**Re: Response to Staff Recommendation and Report Presented to  
the Civic Works Committee on October 4, 2016, RE: "Mud Creek Municipal Class  
Environmental Assessment Study -- Status Update and Scope Change"  
As it relates to the 323 Oxford Street West (Sam Katz Holdings Limited)**

MUD CREEK  
CONCEPTUAL CREEK ALIGNMENT - PLAN

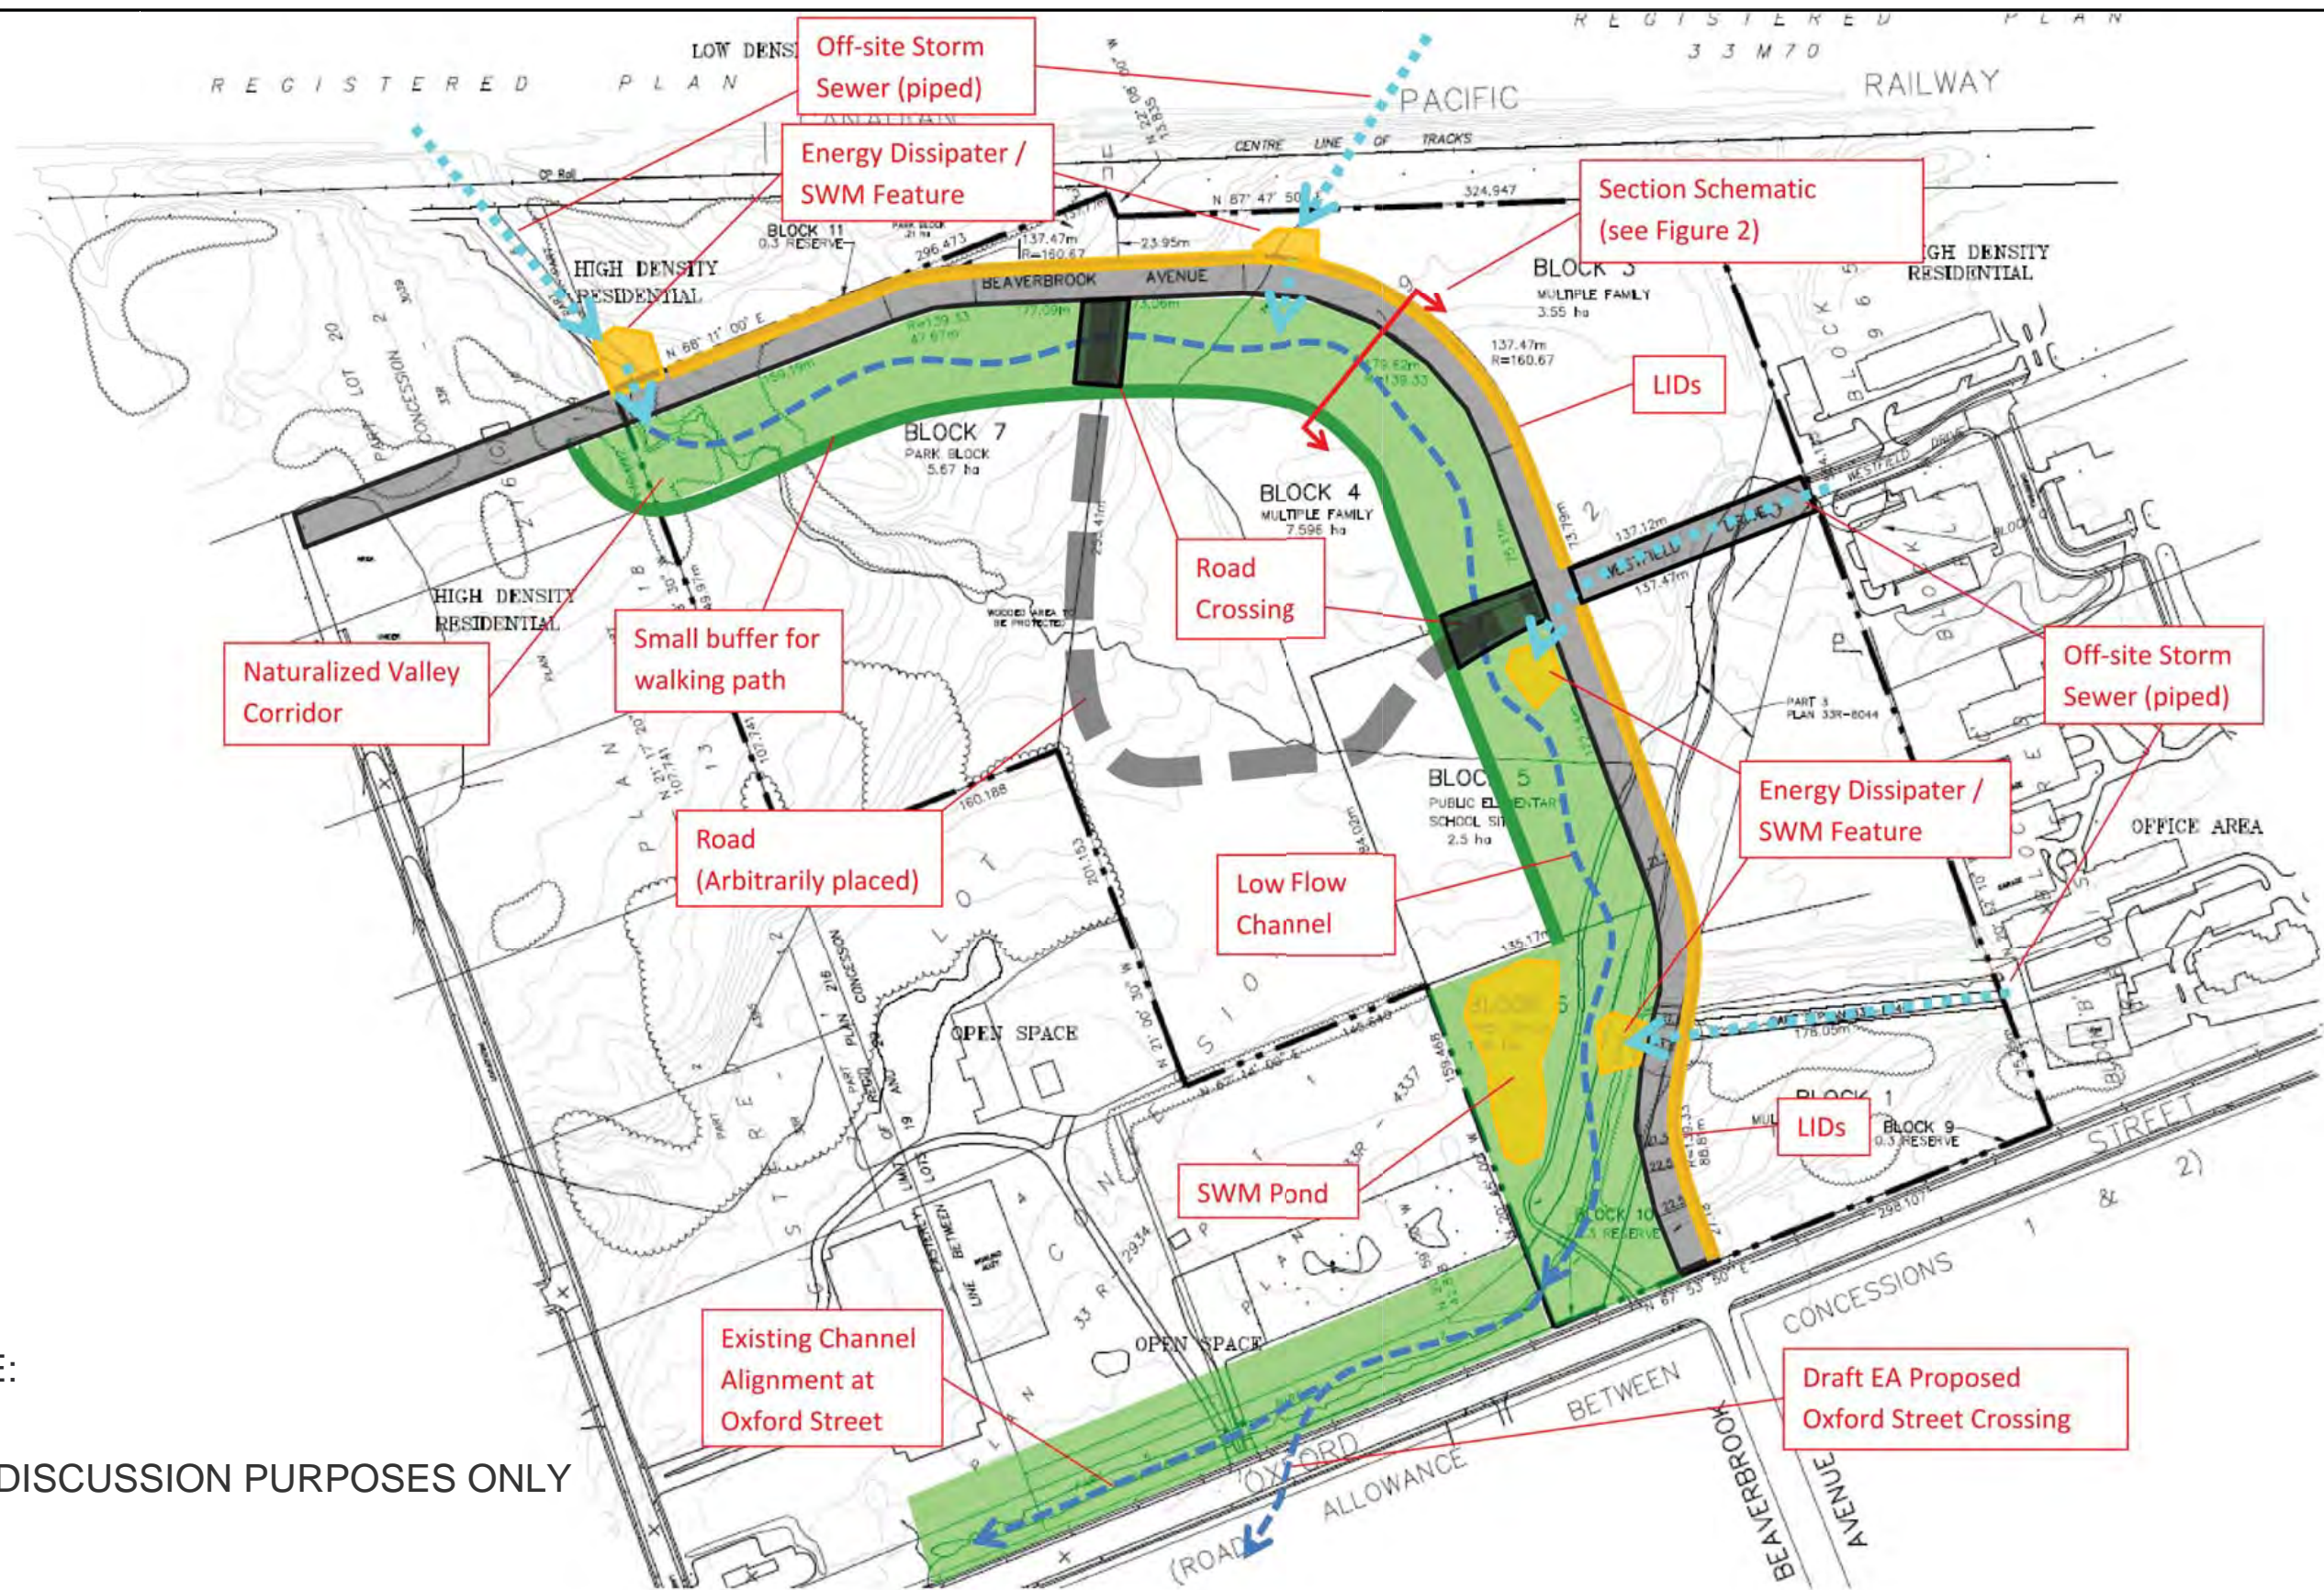
As the first stage of their work, TMIG has arrived at a preliminary concept (attached) that includes:

- A defined, naturalized valley corridor with a meander belt and riparian storage that effectively controls and manages storm flows;
- Significant and sustainable environmental improvements to this area of the watershed;
- Best management practices, included LIDs, that improve water quality and aquatic and terrestrial habitat;
- A connected green system that includes a recreational network and pedestrian connections; and
- More effective and controlled flood mitigation reducing the impact of municipal stormwater flooding on private property.
